Attachment 2. Proposed Changes To Technical Specifications, Pages 37 and 38.

6. ADMINISTRATIVE CONTROLS

Figure 6.1 Organizational structure of the University of Missouri related to the UMR Nuclear Reactor Facility.

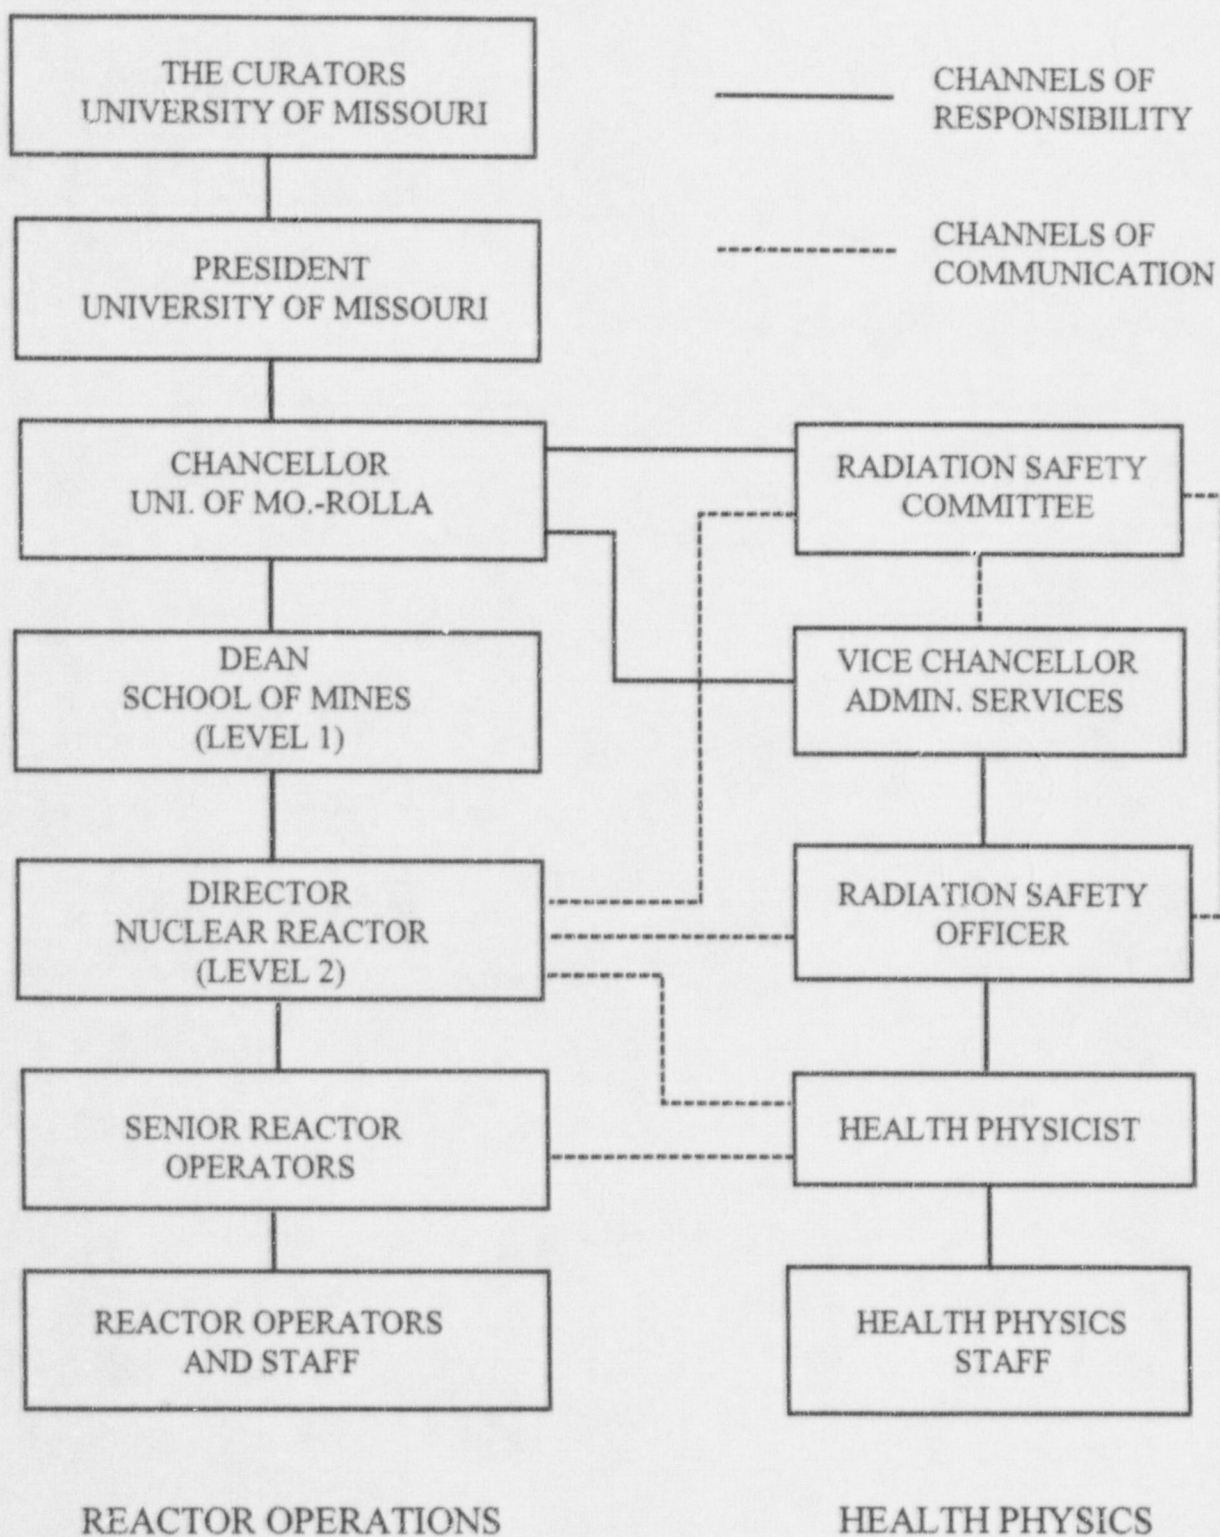
The Nuclear Reactor Facility is a part of the School of Mines and Metallurgy of the University of Missouri-Rolla. The organizational structure is shown in Figure 6.1.

The Dean of the School of Mines and Metallurgy is the individual responsible for the reactor facility's licenses (Level 1).

The Director of the Nuclear Reactor Facility is the contact person for the NRC and has overall responsibility for management of the facility (Level 2). The Director shall be responsible for the day-to-day operation and for ensuring that all operations are conducted in a safe manner and within the limits prescribed by the facility license and the provisions of the Radiation Safety Committee.

The Director shall have a minimum of six years of nuclear experience. The Director shall have a Bachelor's (or higher) degree in engineering or science. Equivalent education or experience may be substituted for a degree. The degree may fulfil four years of the six years of nuclear experience required. As soon as reasonably possible after being assigned to the position, the Director shall obtain and maintain a NRC Senior Operators license.
